PROJECT: Skye Canyon - Phases 3B & 3C Infrastructure - Update #2

CITY OF LAS VEGAS INTER-OFFICE MEMORANDUM				DATE: April 9, 2020
TO: **Land Development Services** Department of Building & Safety				FROM: Jennifer Shinn, P.E. Flood Control, Engr. Associate Department of Public Works
SUBJECT:	Drainage Study for: **Skye Canyon – Phases 3B & 3C Infrastructure – Update #2**			**COPIES TO:** Westwood Professional Services
Cross Streets:	NWC of Skye Village Road & Skye Canyon Park Drive			M F Land LLC / Ninety-Five Management LLC
File Number:	F:\Depot\DSMemos\DS4953E.doc			Bart Anderson, P.E., DevCo
Parcel Number:	126-12-101-002			CCRFCD
Zoning Action:				
FEMA Flood Zone	YES	NO **X**		
Proposed Storm Drain	YES **X**	NO

5th Submittal: Update #2 to address Land Use changes, upsize facilities accordingly, and shifts in SD alignment due to utility conflicts

PP-05
SHEET 10 OF 47

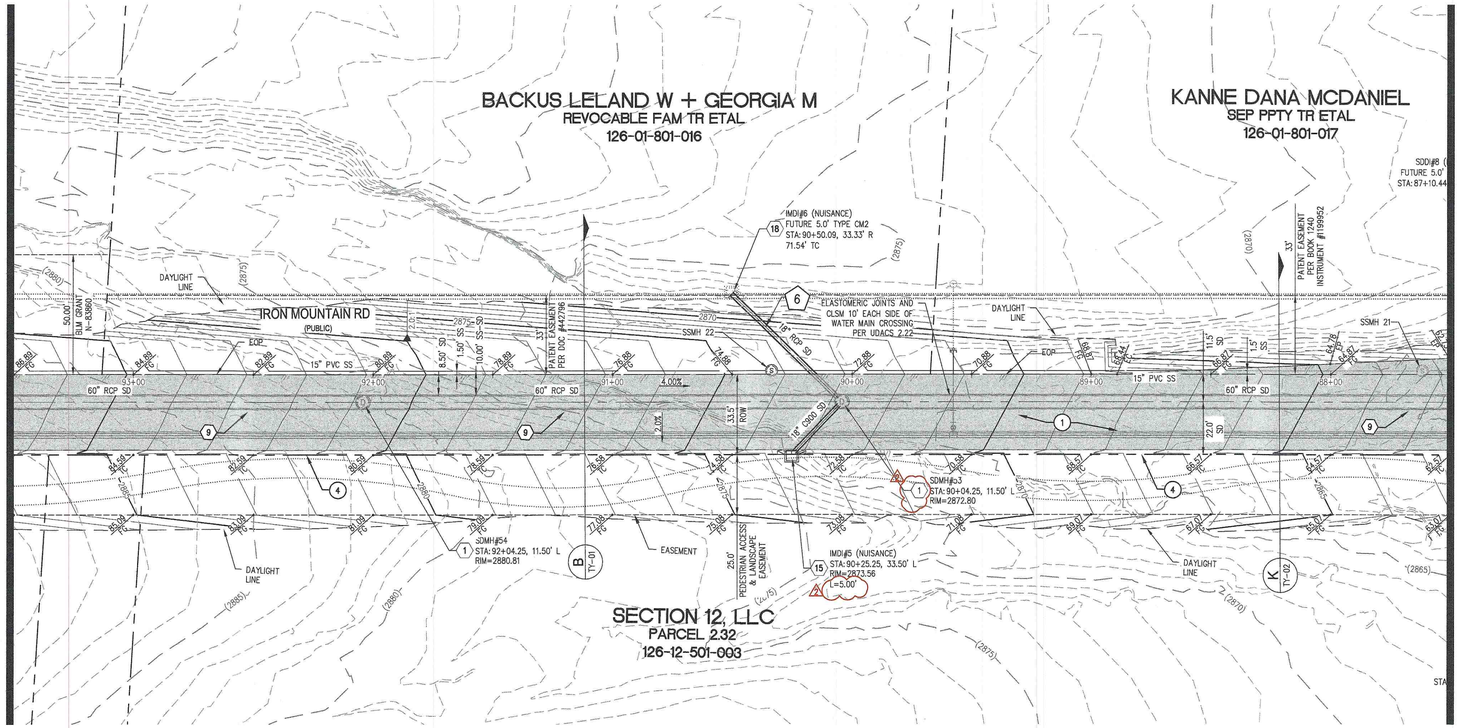
Sheet PP-05: Label the length of the proposed drop inlet at Sta. 94+36.89 (**second request**).

Sheet PP-05: Label the length of the proposed drop inlet at Sta. 94+36.89.

PP-04
SHEET 8 OF 44

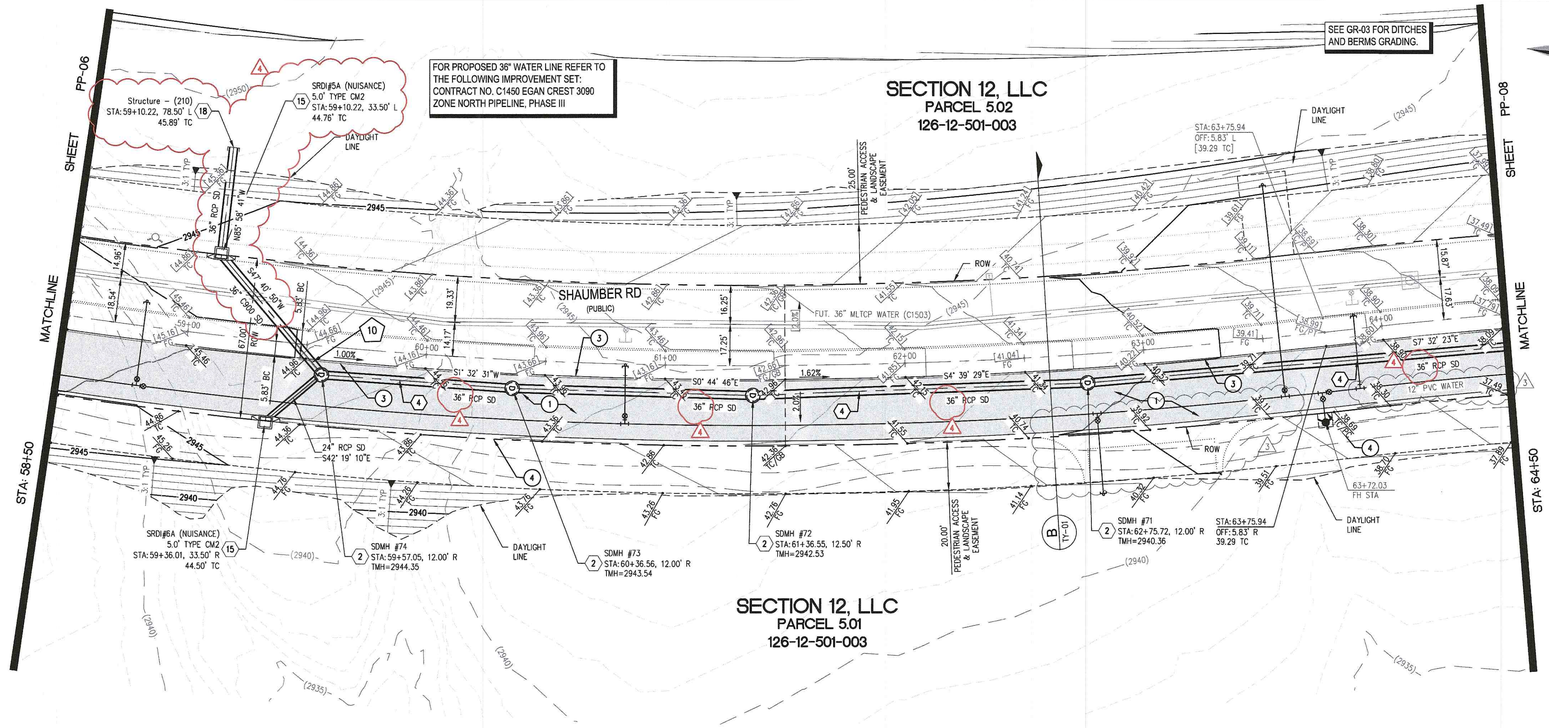
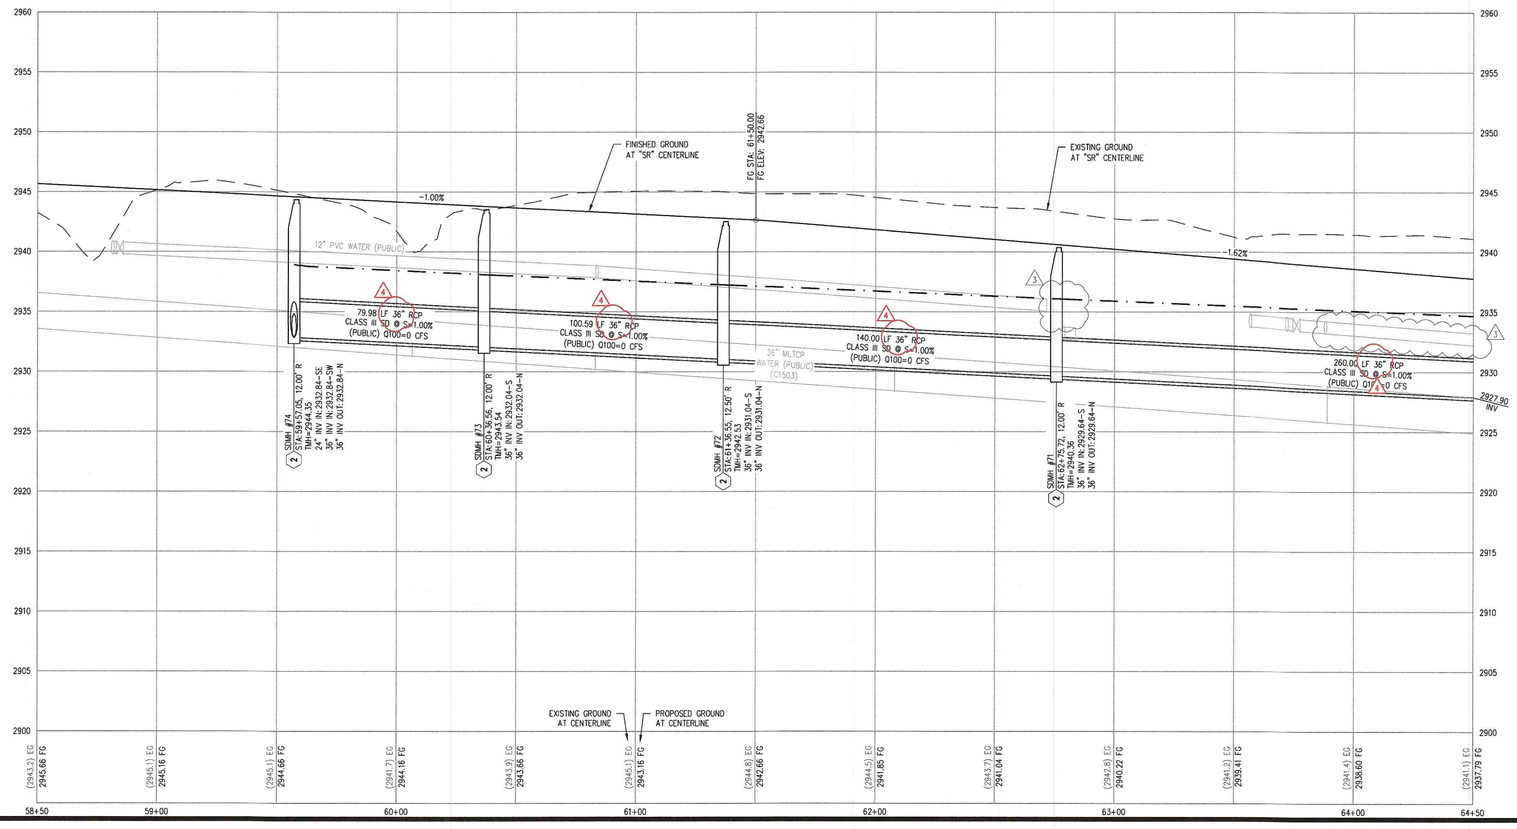
- SHEET PP-02: Reach of 54-inch C900 SD pipe revised to 54-inch RCP with elastomeric joint sealant at water line crossing.
- SHEET PP-04: Previous plans included an interim reach of storm drain pipe east from SDMH #20 to discharge flow downstream at this location. However, due to the removal of interim discharge pipes from the Skye Village Road plans with Skye Canyon Phase 3A improvements downstream, there is no longer a benefit to this interim discharge pipe and it is being removed from the proposed improvements.

- SHEET PP-03, PP-04: The proposed storm drain alignment shift in Shaumber Road is revised to provide horizontal clearance for the revised water line alignment. That storm drain revision results in the tie-in location in Iron Mountain Road being moved to the west. SDMH #59 is proposed to be revised from "IMR" Station 106+42.59 to Station 106+52.92. The invert out elevation at the manhole is also revised, from 2922.56-ft to 2020.88-ft. The change in elevation affects the first reach of storm drain pipe downstream of SDMH #59 in Iron Mountain Road. The next manhole, SDMH #58 holds the same invert as the previously approved plans. WSPG hydraulic modeling of the revised storm drain facility is included in Appendix C.

Sheet PP-04: Explain why the drop inlet is in a "sump" condition.
